Peach Bottom Atomic Power Station, Units 2 and 3
Renewed Facility Operating License Nos. DPR-44 and DPR-56
Docket Nos. 50-277 and 50-278

Subject: Response to Request for Additional Information Concerning
License Amendment Request – Application of Alternative Source Term

**License Amendment Request
Response to Request for Additional Information**

Revised FIGURE 1

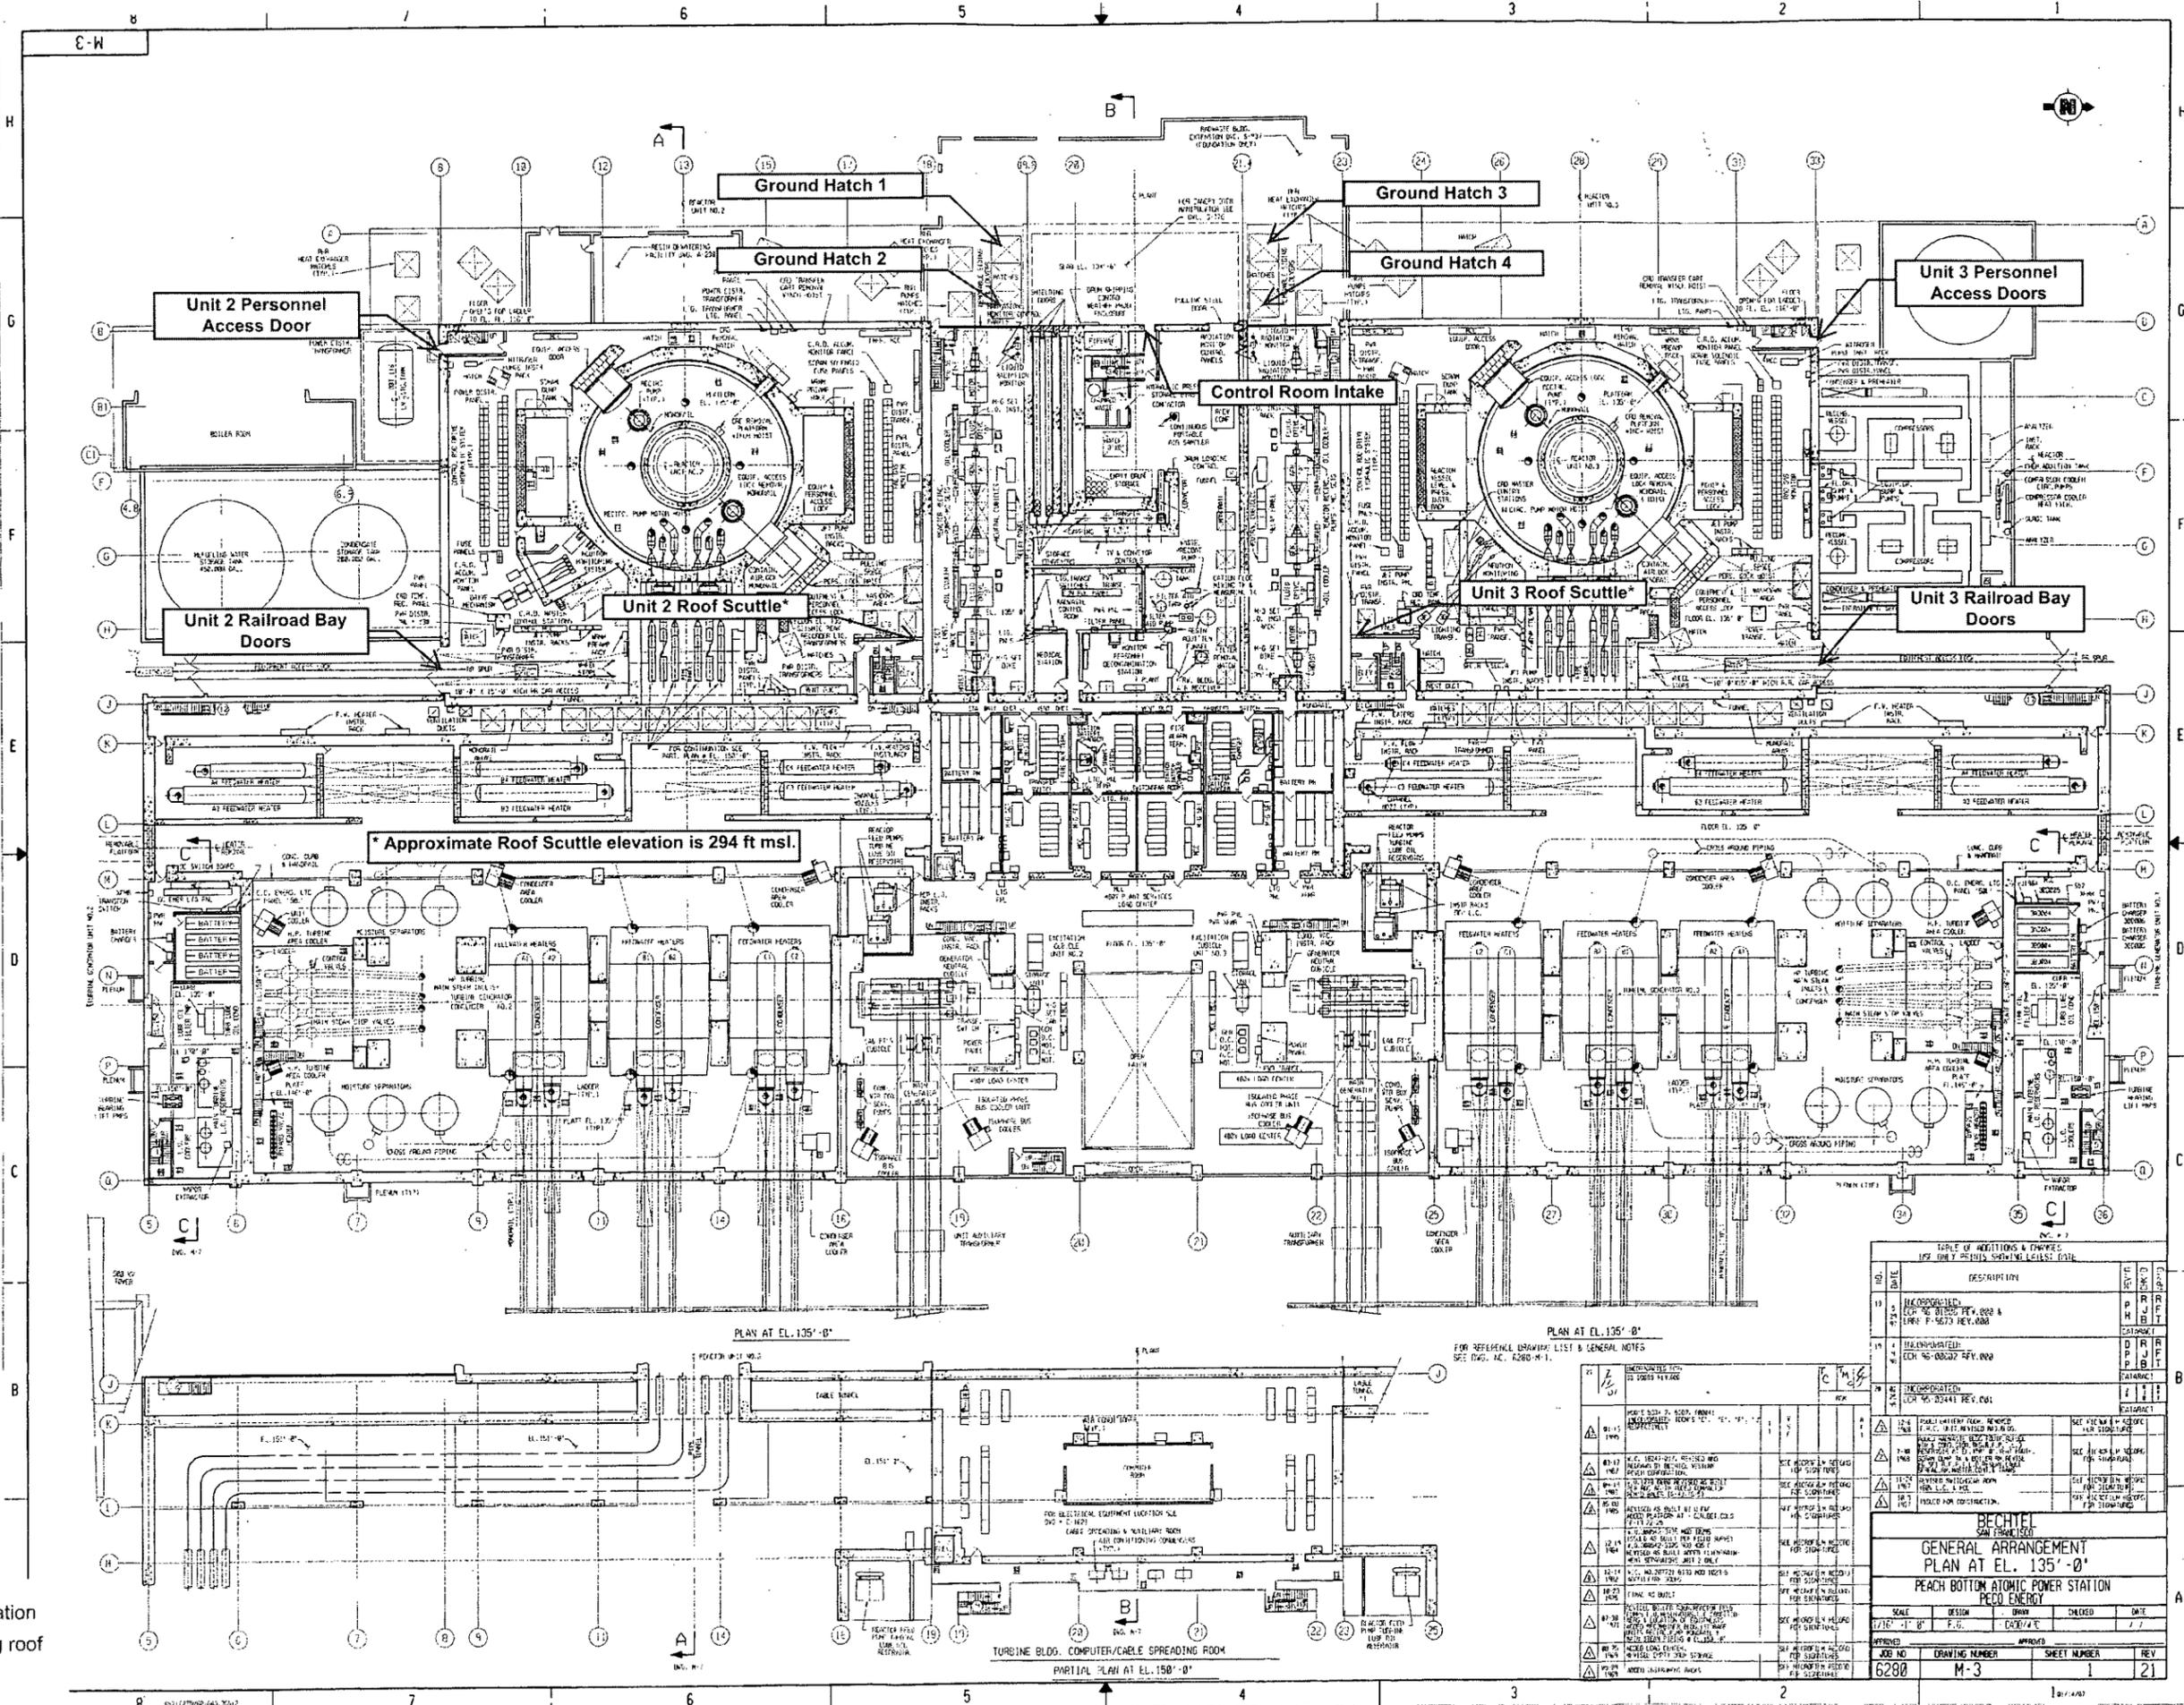
Figures 1 and 2 associated with the response to NRC Question 18 (AADB RAI 18) state that the Units 2 and 3 roof scuttles are at 183.5 ft (55.9 m) msl. Page 13 of Attachment 1 of the July 13, 2007 alternative source term license amendment request states that plant grade is 35.4 m. This would suggest that the roof scuttles are 20.55 m above plant grade. However, Table 3-1 of Attachment G to Calculation PM-1059 of the July 13, 2007 letter lists the release height of the roof scuttles as 48.5 m. Please provide additional information to clarify the height of the roof scuttles and justify that the value of 48.5 m input to the ARCON96 computer calculations.

In response to NRC Question 18 (AADB RAI 18) in the May 23, 2008 submittal, Figures 1 and 2 were provided which included an asterisked annotation indicating that the elevation for the Unit 2 and 3 roof scuttles was 183.5 ft msl. This value is not representative of the elevation of the roof scuttles. These figures were provided to help improve reader clarity in highlighting the source and receptor locations. The information depicted on the figures was based on information from Figure 3-1 in Attachment G to Calculation PM-1077, Revision 2.

The figures have been revised to reflect the appropriate elevation for the Units 2 and 3 roof scuttles (i.e., approximately 294 ft msl). In addition, Figure 3-1 of Attachment G to Calculation PM-1059, Revision 2, will also be revised during the next revision to accurately reflect the elevation of the roof scuttles. It is expected that the revision to Calculation PM-1059 will be completed in conjunction with providing the supplemental response to address NRC Question 4 (AADB RAI 23).

PBAPS AST LAR - RAI Response
Question 18 (AADB RAI 18) Supporting Information
Revised in response to AADB RAI 24 regarding roof
scuttle elevation.
